From: "Moorer, Tom C." <TCMOORER@southernco.com>
To: "Mark Notich" <mdn@nrc.gov>, "Michael R Sackschewsky" <michael.sackschewsky@pnl.gov>
Date: 12/7/2006 10:51:00 PM
Subject: TtNus responses to Questions for NRC Audit (2) current rev (2)TCM.doc

Information Needs for the Vogtle Early Site Permit Environmental Review

Figure 1. Fuel prices to electricity generators, 1995-2030 (2004 dollars per million Btu).

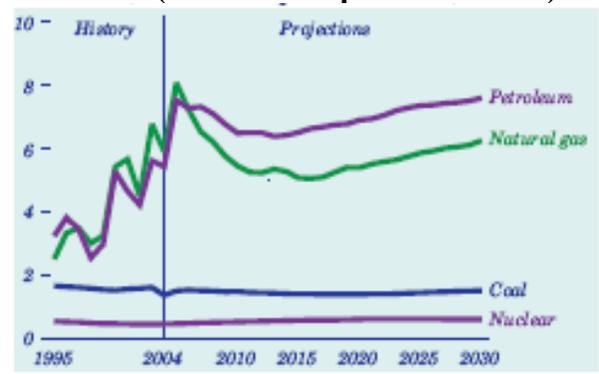
214	Need chart of 20 year expected peak loads, consumption, price of oil projections, coal, gas and nuclear.	Need for Power	Mike Dusaniwskyj

#	Information Need	Discipline Name	Reviewer Name
	<p>Response: Fuel Cost Projection</p> <p>The cost of producing electricity is a function of the costs of fuel, operations and maintenance, and capital. In Energy Information Administration (EIA) projections for the year 2030, fuel costs would account for about two-thirds of the generating costs for new natural-gas-fired plants, less than one-third for new coal-fired units, and less than one-tenth for new nuclear power plants (EIA 2006, at page 82). As shown in Figure 1, coal- and nuclear-fuel costs have remained relatively steady for the past 10 years but natural gas and petroleum costs have risen significantly. Projections of fuel costs, therefore, bear significantly on the analysis of the cost of producing electricity using the various fuel options. EIA projections show petroleum and natural gas prices dropping but then rising again towards the end of the projection period. Table 1 shows values for selected years shown in Figure 1.</p>
